STATE OF MAINE
DEPARTMENT OF TRANSPORTATION
16 STATE HOUSE STATION
AUGUSTA, MAINE 04333-0016

January 22, 2018
Subject: Billings Bridge
Superstructure Replacement
State WIN: 022618.00
Location: **Paris**
Amendment No. 2

BILLINGS BRIDGE OVER
LITTLE ANDROSCOGGIN RIVER
OXFORD COUNTY
PARIS
ABUTMENT NO. 2
REMOVAL AND REPAIRS

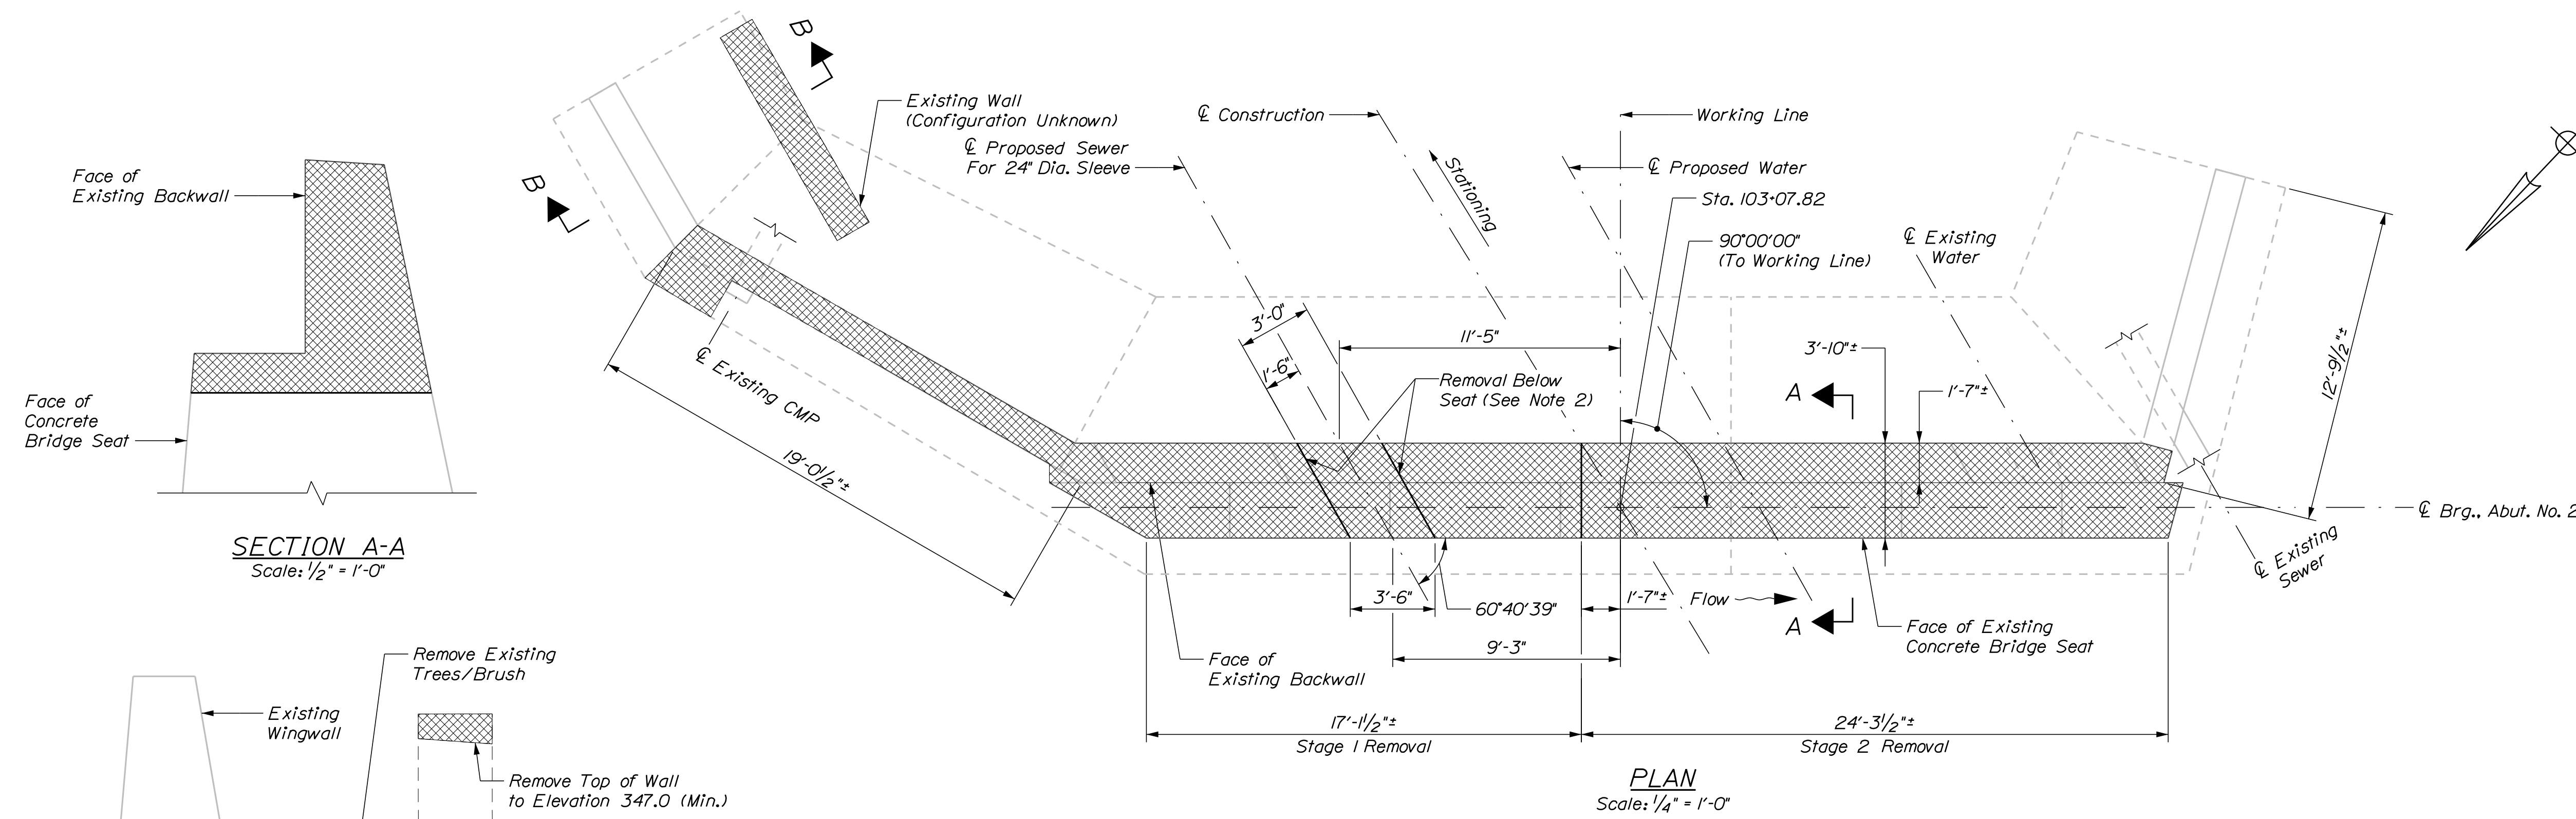
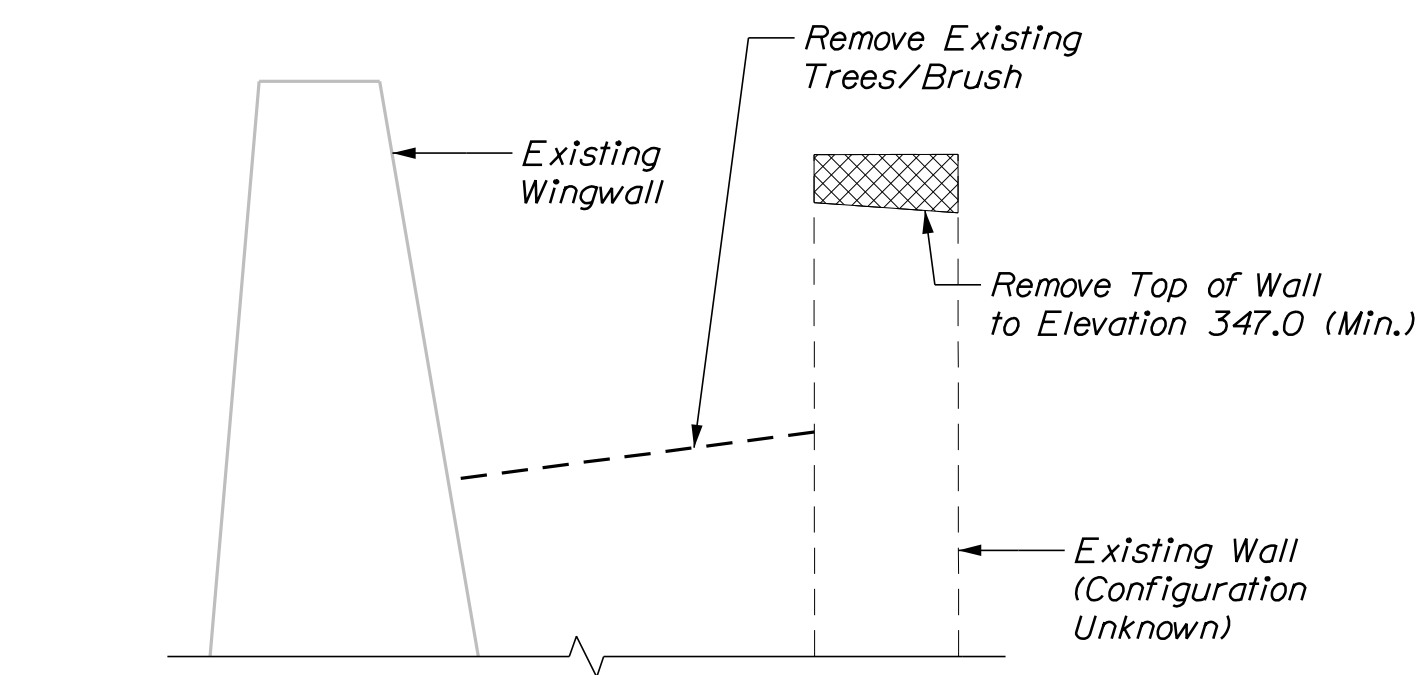
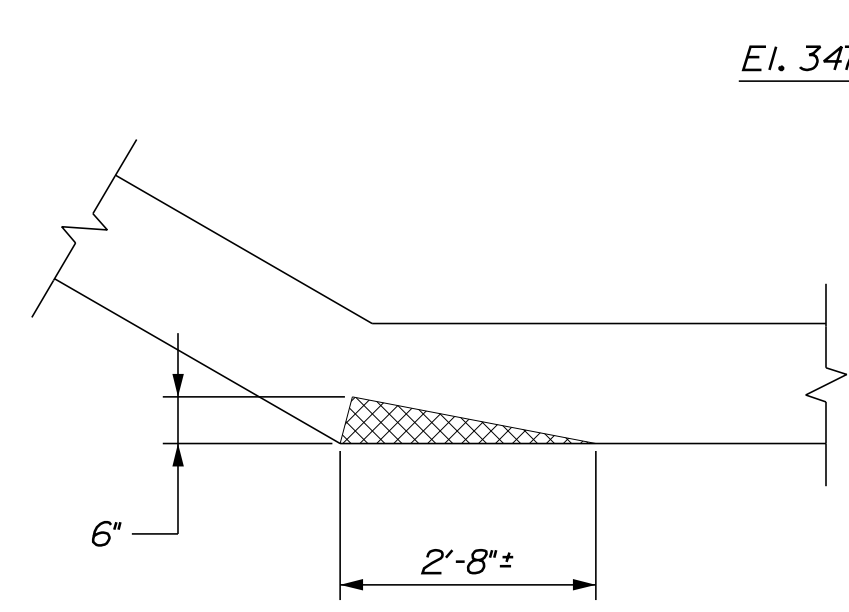
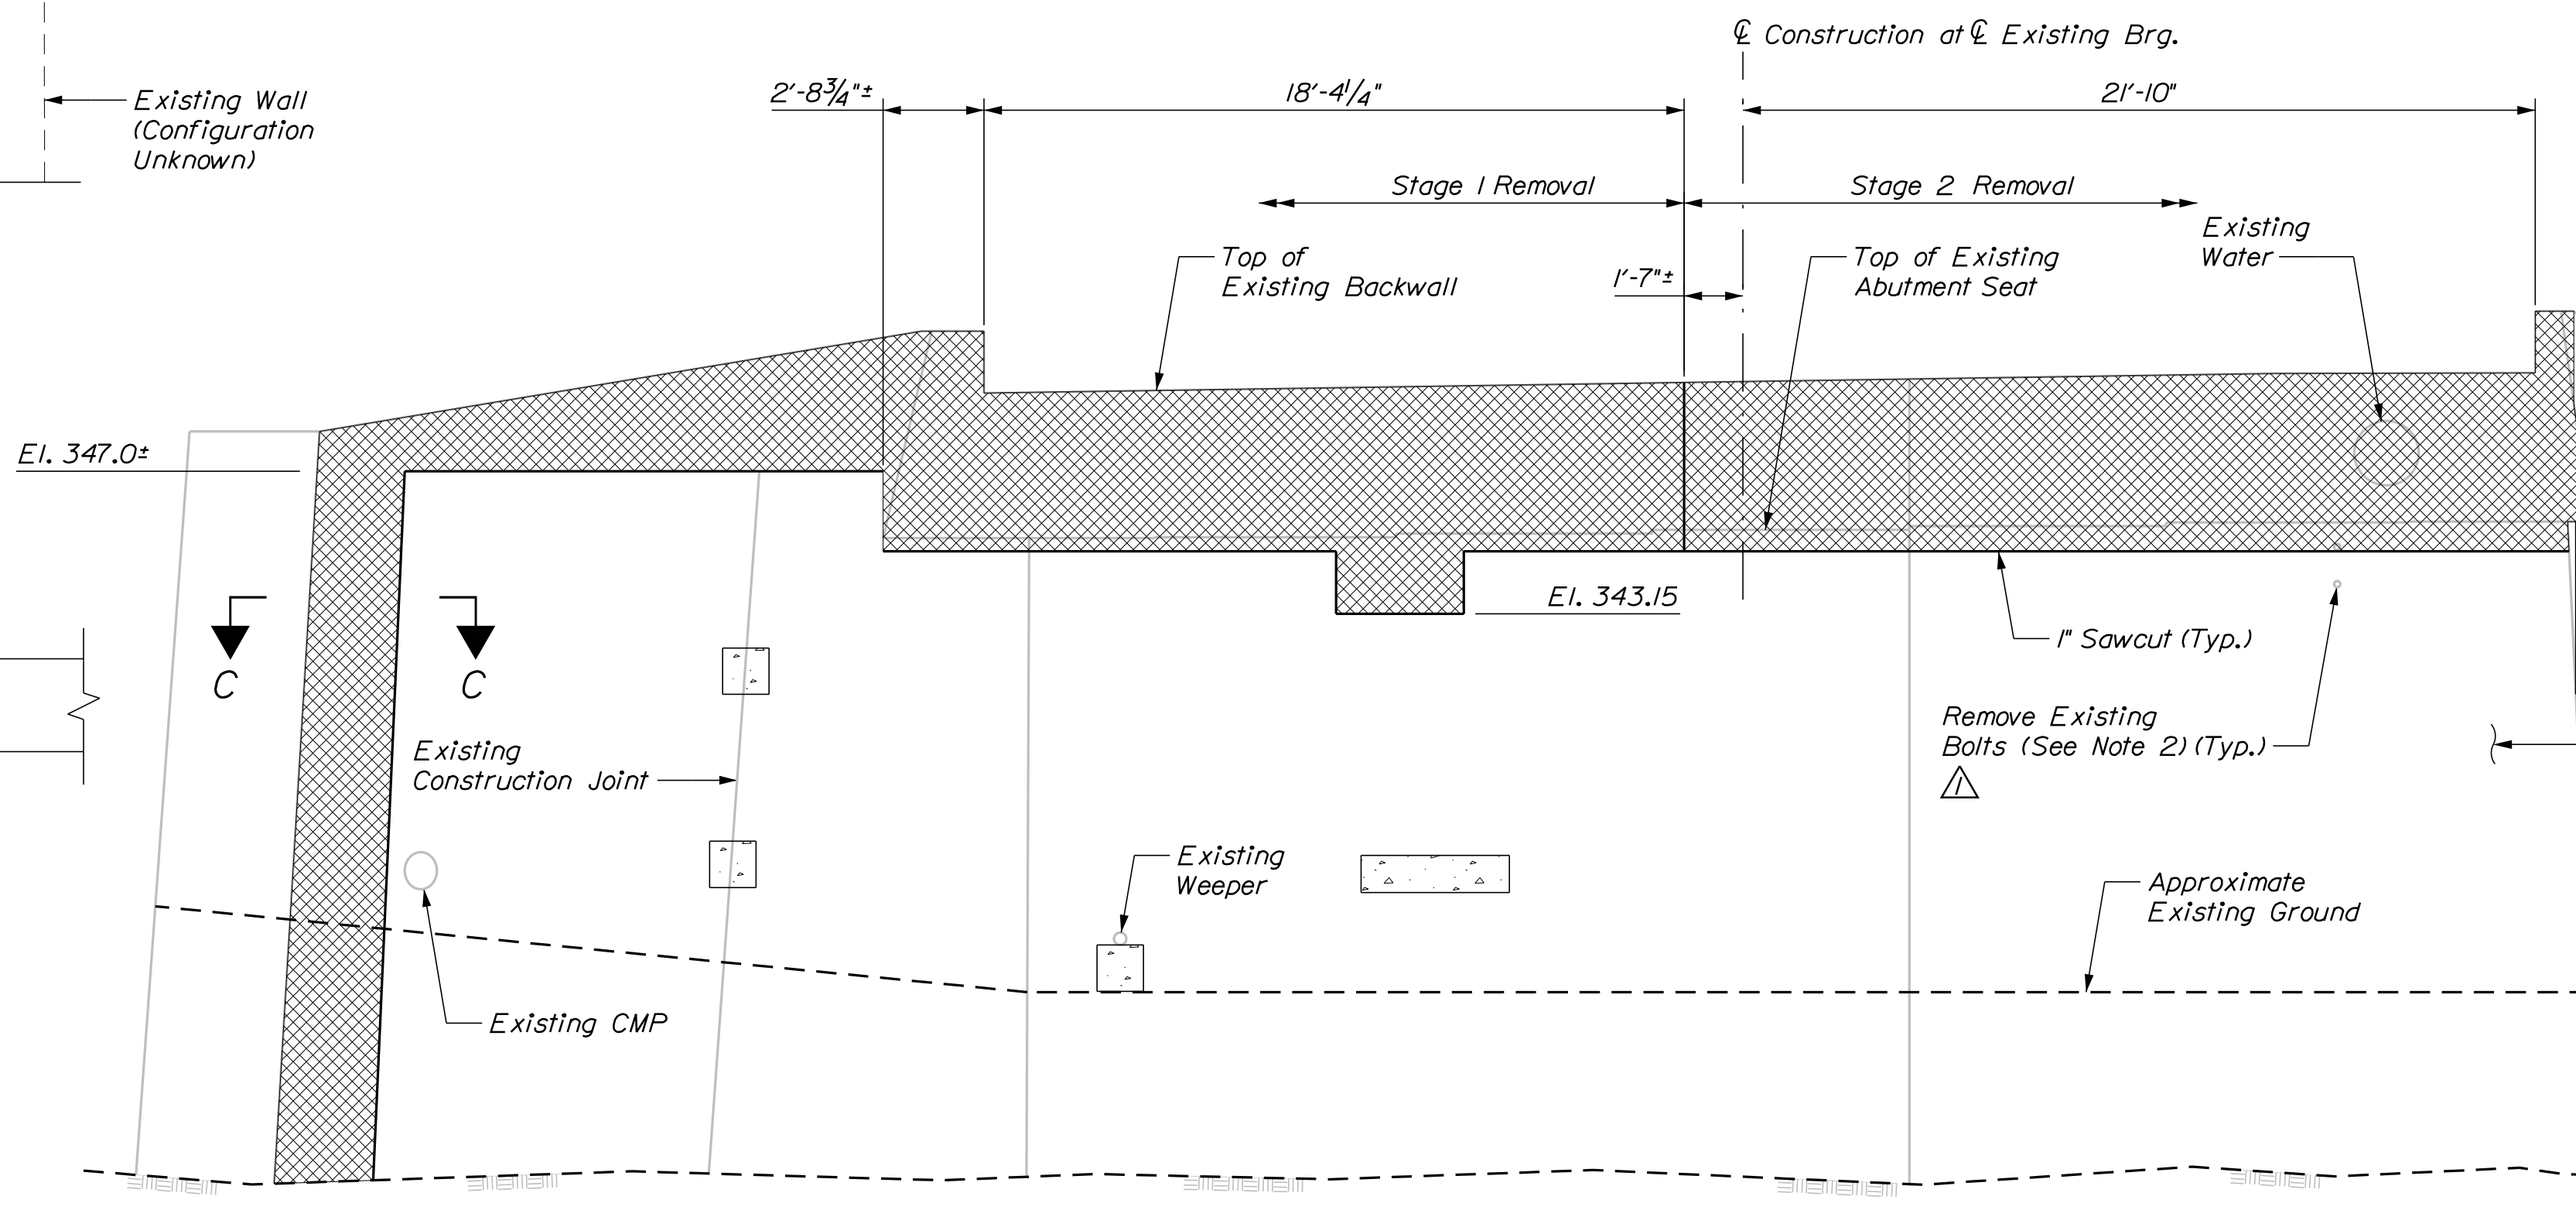
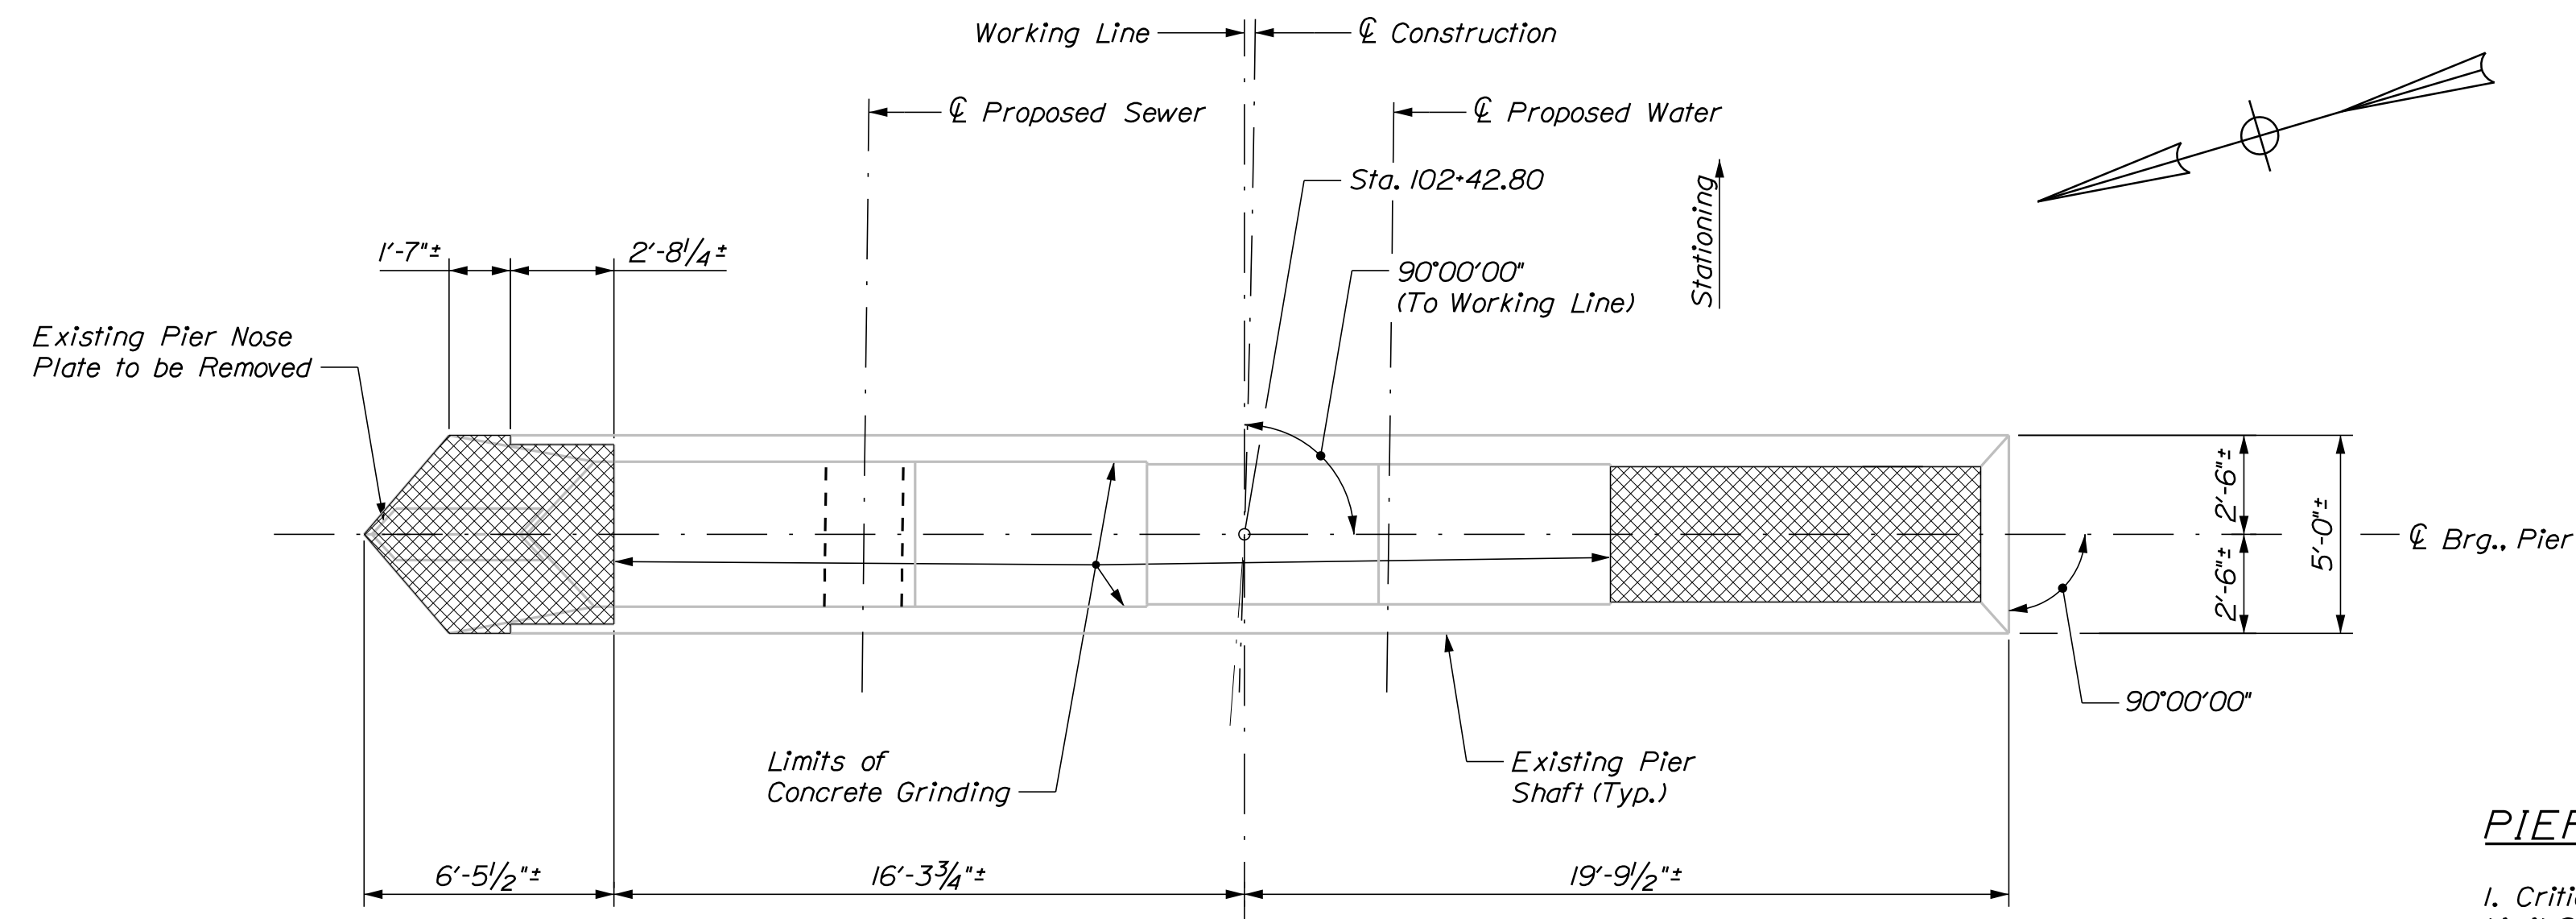
Deleted Stage 1 and Stage 2 Reference
